# Door Handle Deformation Complaints On '66 Ponies

The Mustang Times/March, 1993

Fig. 10 - Deformation of Inside Door Handle Escutcheon Plate - (Article 559)

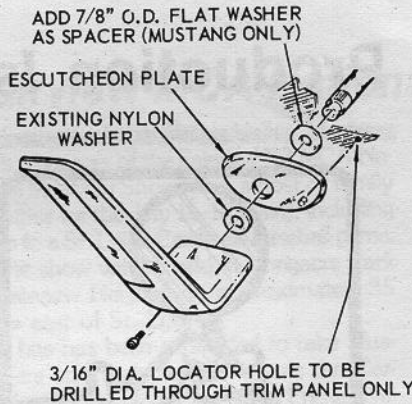
Some units may show evidence of a deformed or scored inside door handle escutcheon. Investigation has revealed that the escutcheon locator hole was not positioned correctly in the door trim panels on some models and was omitted entirely on other models. As a result of this, the locator pin on the escutcheon could not be seated correctly on the trim panel, thereby permitting deformation and/or scoring of the escutcheon.

This problem was corrected in production on Nov. 2, 1965 by locating and piercing the escutcheon locator hole in the trim panel to eliminate distortion or scoring.

1. Remove the door inside handle and escutcheon.

2. Obtain a new escutcheon and locate it correctly by pressing the escutcheon firmly against the trim panel.

3. Pierce or drill a 3/16-inch diameter hole through the trim panel only at the indentation made by the locator pin on the escutcheon. (See Illustration).

**Note:** In some cases a mislocated hole may already exist in the trim panel. If it interferes with an attempt to locate the new hole, enlarge the existing hole to allow correct escutcheon installation.

4. Position the escutcheon and install the door handle.

**Note:** A 7/8 O.D. flat washer should be added between the trim panel and escutcheon.
